Plan Holders of: **GRETCHEN TALLEY PARK – PHASE III IMPROVEMENTS
1551 DOVE DRIVE, TRACY, CA – CIP NO. 78170**

Subject: Addendum No. 2

ADDENDUM NO. 2

THE CONTRACTOR SHALL CALL U.S.A. (800) 642-2444 AND THE CITY OF TRACY (209) 831-6400 AT LEAST 48 HOURS IN ADVANCE BEFORE THE START OF EXCAVATION.

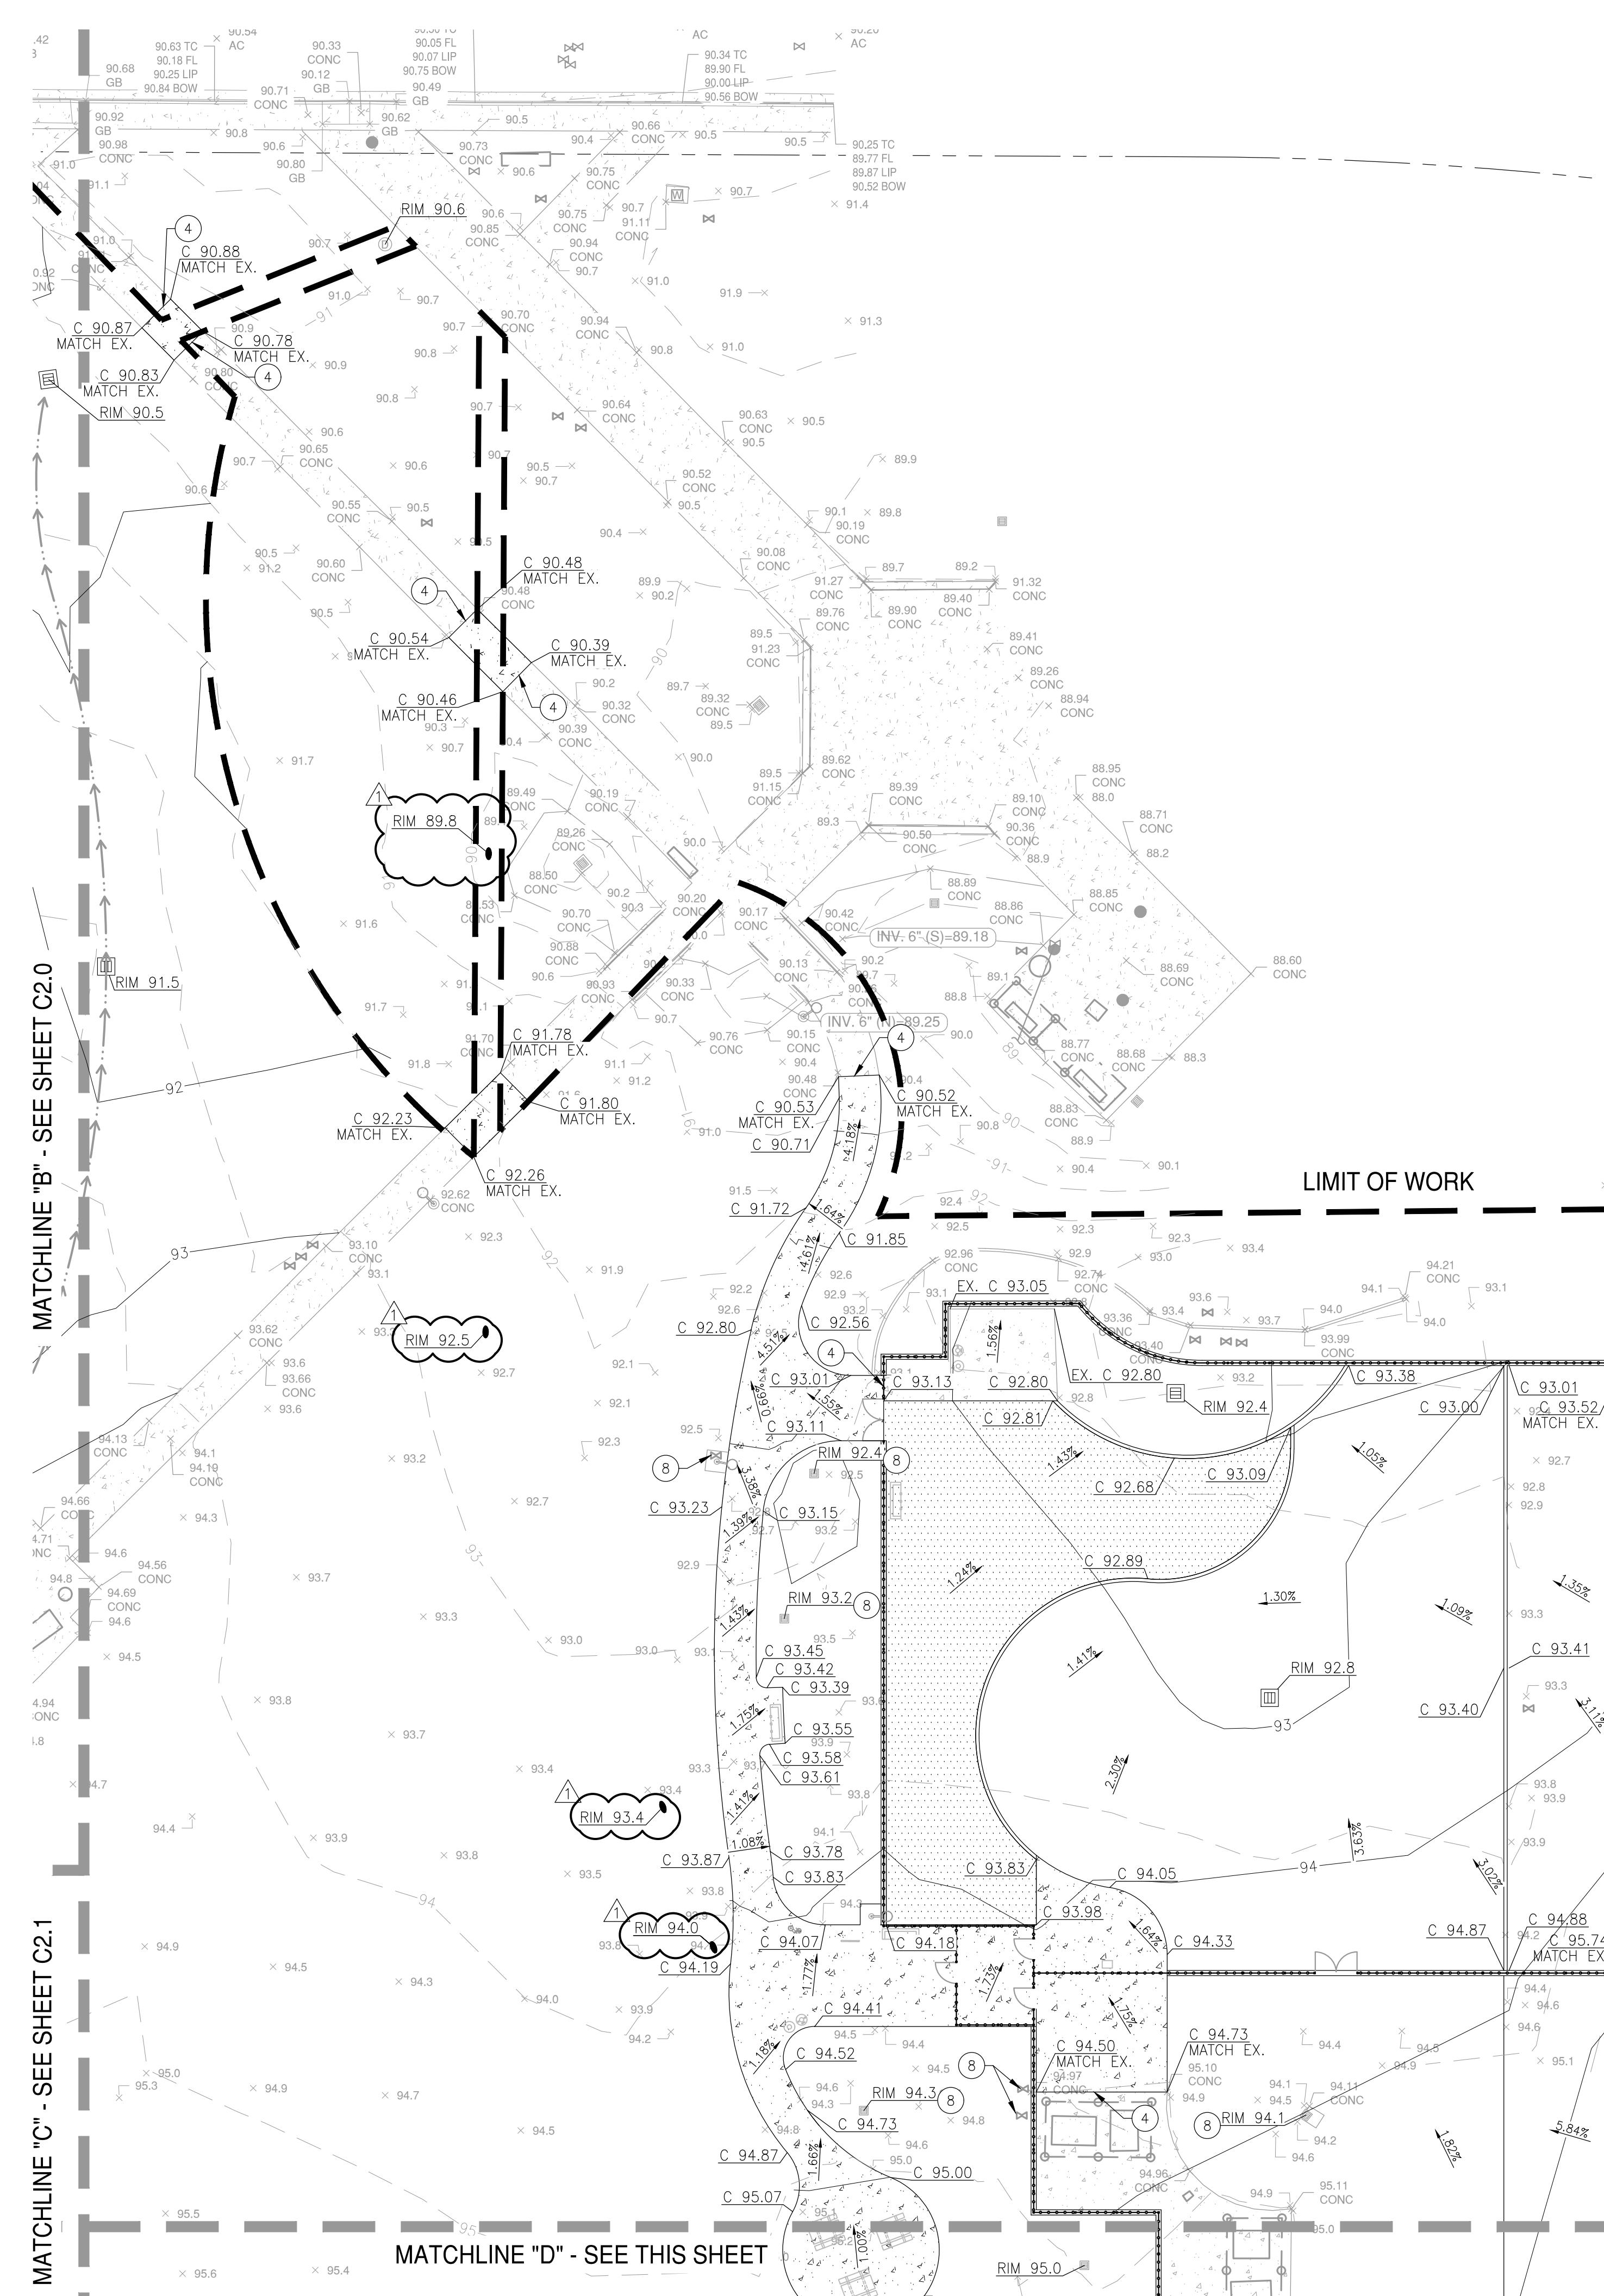
Item No. 1	L2.0 – Additional sawcut and removal with grinding in specified locations and modifications to demolition legend.
Item No. 2	C1.0 – Revisions to Sewer and Water Pipe Materials.
Item No. 3	C1.1 – Addition of accessible parking zone section, modification of callout on Detail 3.
Item No. 4	C2.0 – Modification to legend.
Item No. 5	C2.1 – Modification of accessible parking and addition of grinding and overlay and modification to legend.
Item No. 6	C2.2 – Addition of cleanout rim elevations and modification to legend

1 EXPANSION JOINTS / SCORE JOINTS

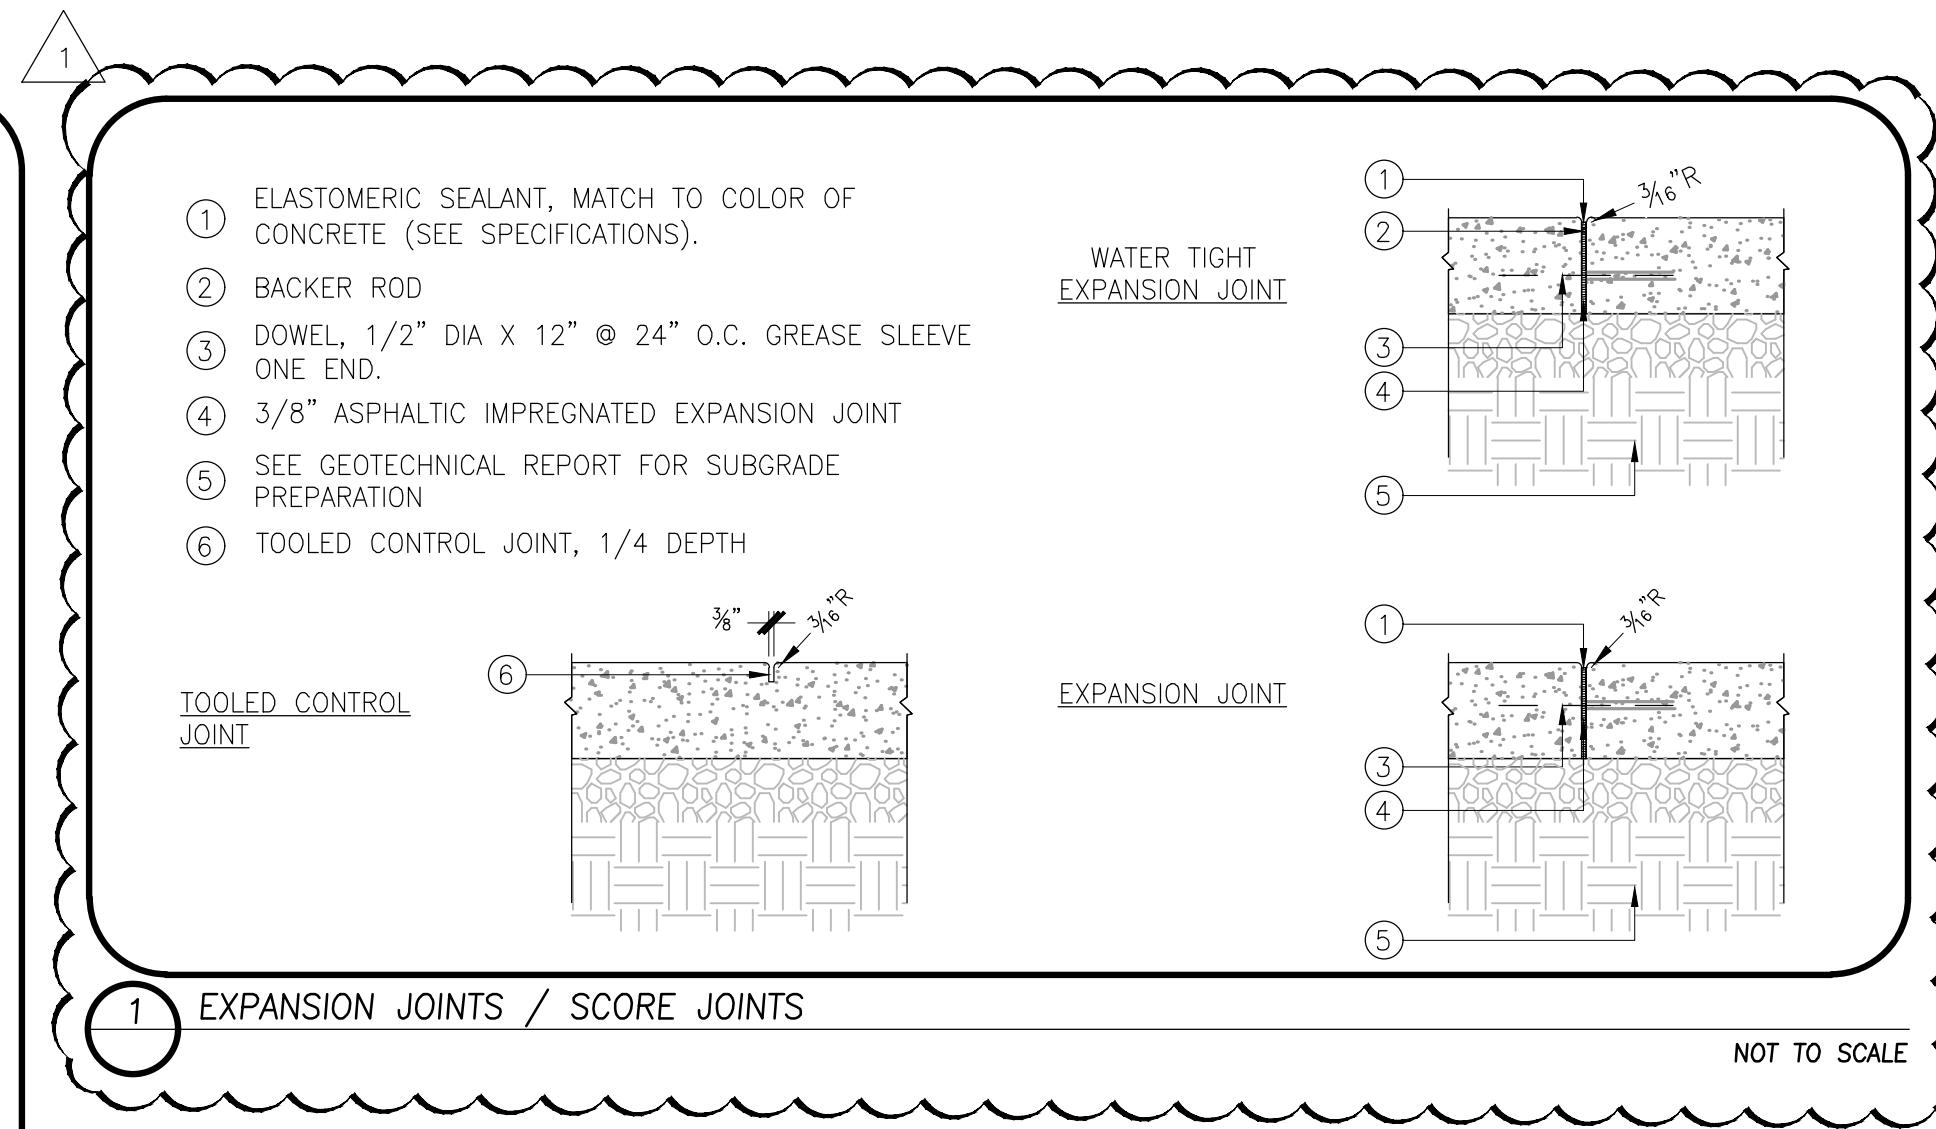
16. QUESTION: *Plans – Sheet C1.2, 1.3 and L7.0 – City Standard Details and Construction Details - Please provide the expansion joint details for the concrete paving and curb or confirm whether dowels are required at these joints. At present, the only detail indicating the use of dowels at an expansion joint is the 6" vehicular concrete paving shown in Detail 6 on Sheet L7.0. If dowels are required, please specify the type and spacing to be used.*

ANSWER: **Refer to newly added detail 1/L7.8 for expansion joint detail. Refer to Sheets L3.1-3.3 for expansion joint locations.**
